HISTORIC LANDMARK COMMISSION
MAY 18, 2015
APPLICATION FOR A CERTIFICATE OF APPROPRIATENESS
C14H-1978-0038
Paramount Theater
713 Congress Avenue

Restore exterior balconies pursuant to an ACVB Heritage Grant.

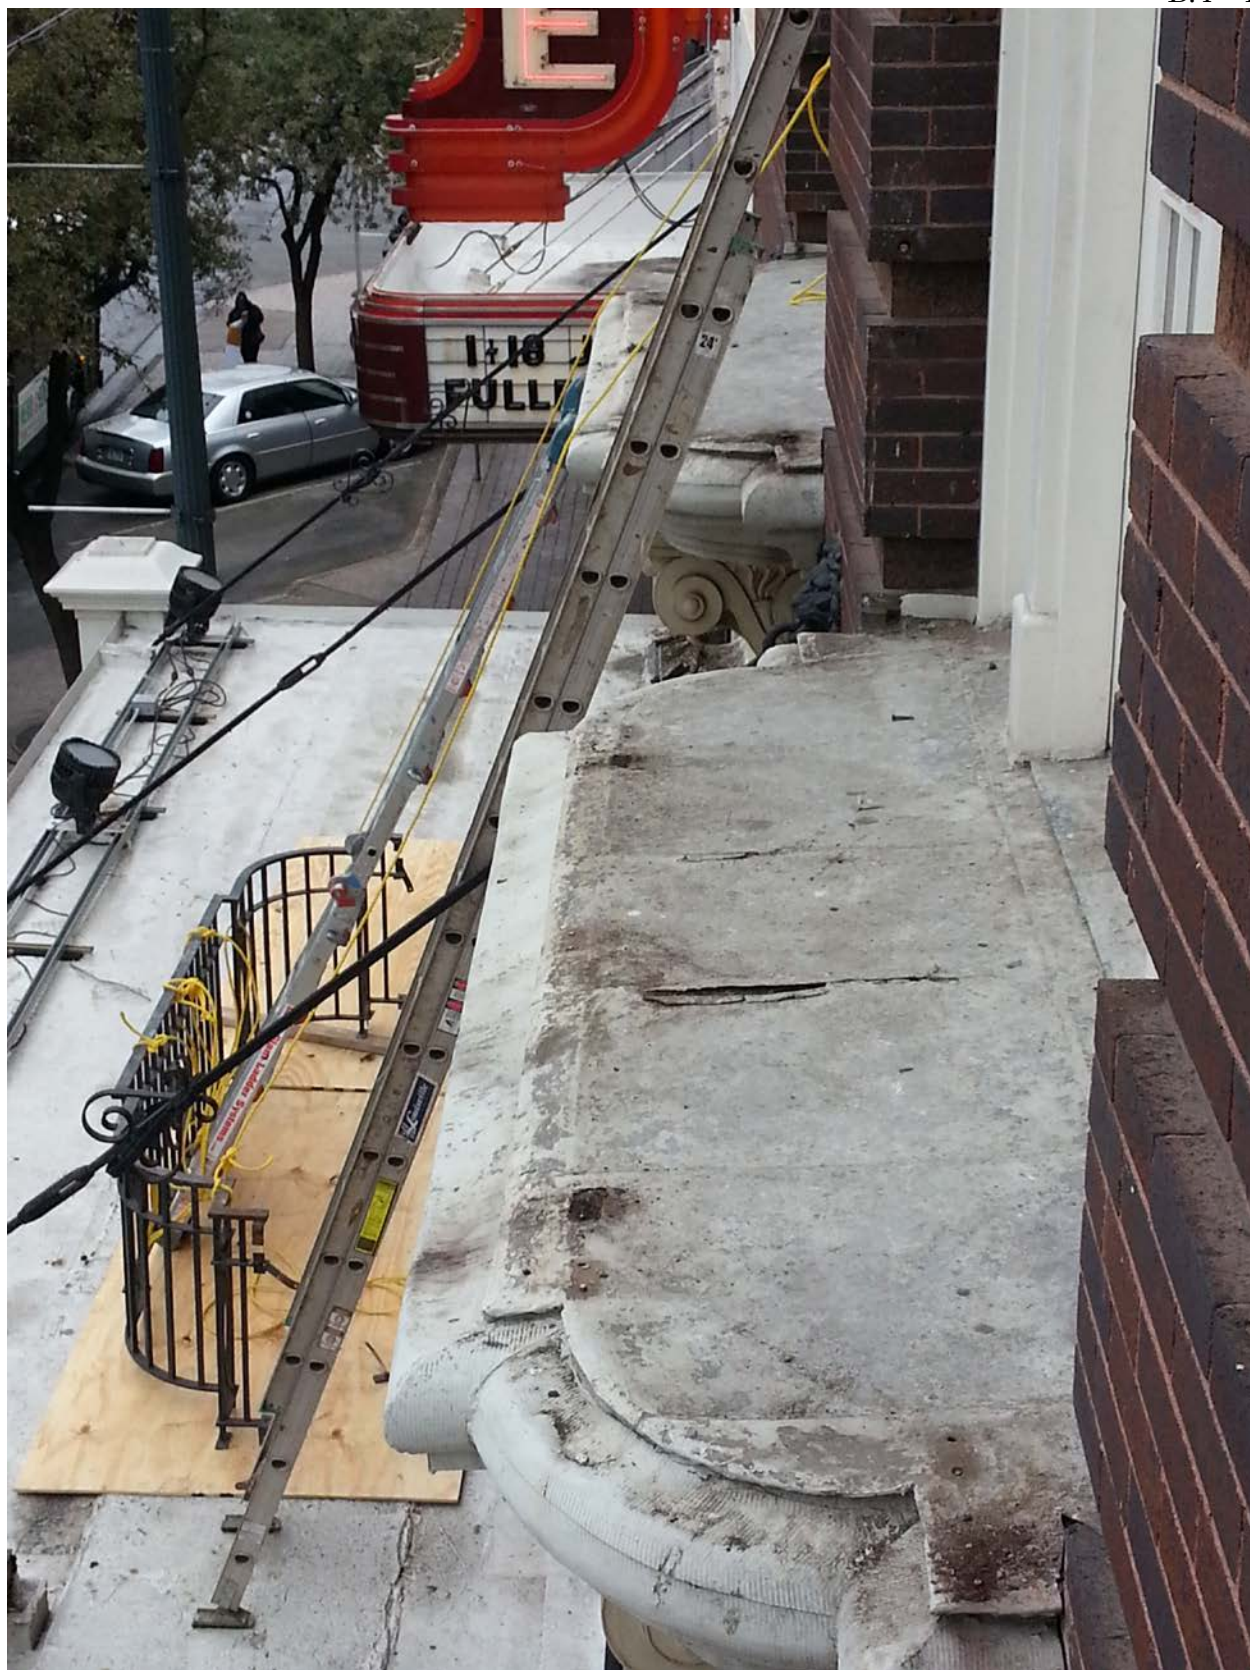
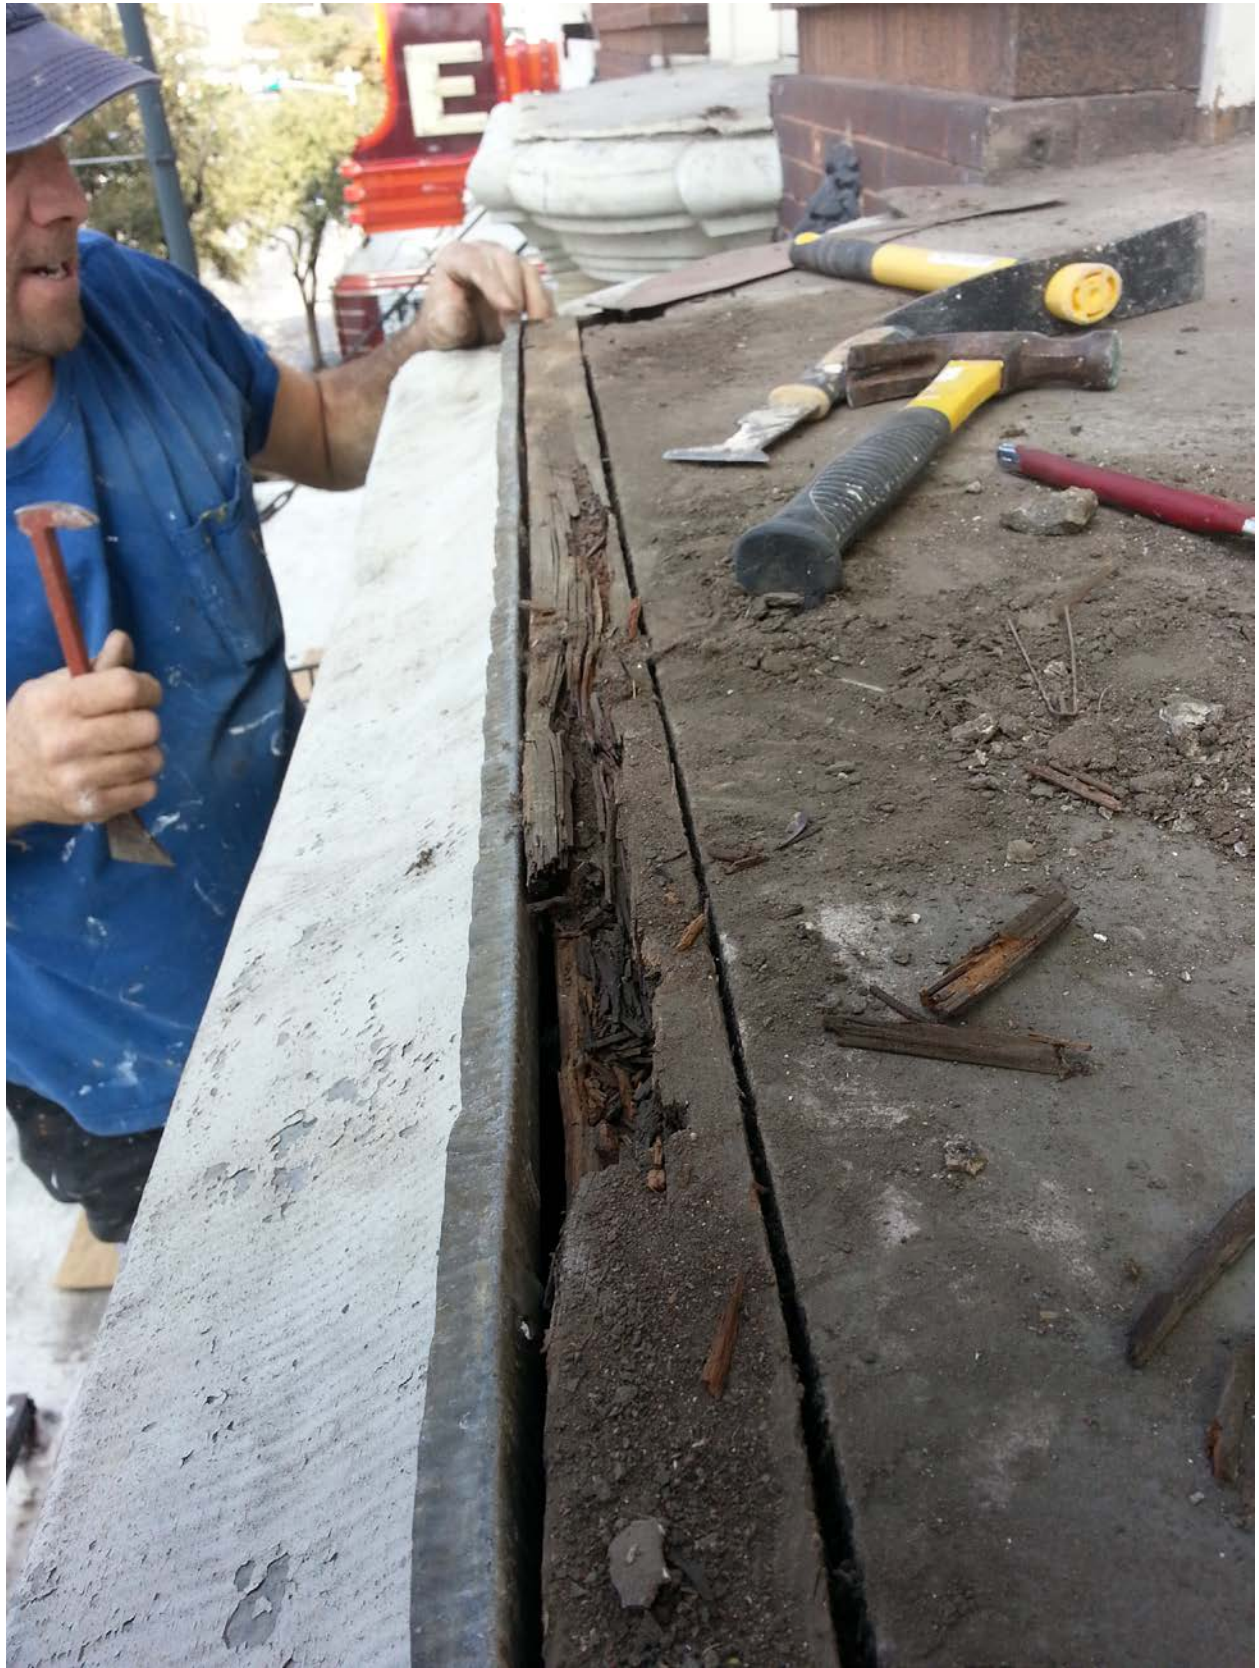
The Committee requested detailed photographs of the existing conditions, and recommended replacing all materials in kind to the greatest extent possible. The Committee further recommended using thermally-treated wood for the flashing backing to avoid a warping problem in the future, and to address the possibility of galvanic action with the reaction of different metals with each other.

Attached are photos of the balconies and flashing details for the new stainless steel decking with terne coating. The new deck is stainless steel and will attach to the existing ornamental galvanized steel wrap. There is no evidence to provide threat of galvanic reaction between the two metals.

We will use either thermal wood or steel to provide fastening points for the balcony metal wraps to prevent rotting wood or reaction to metal.
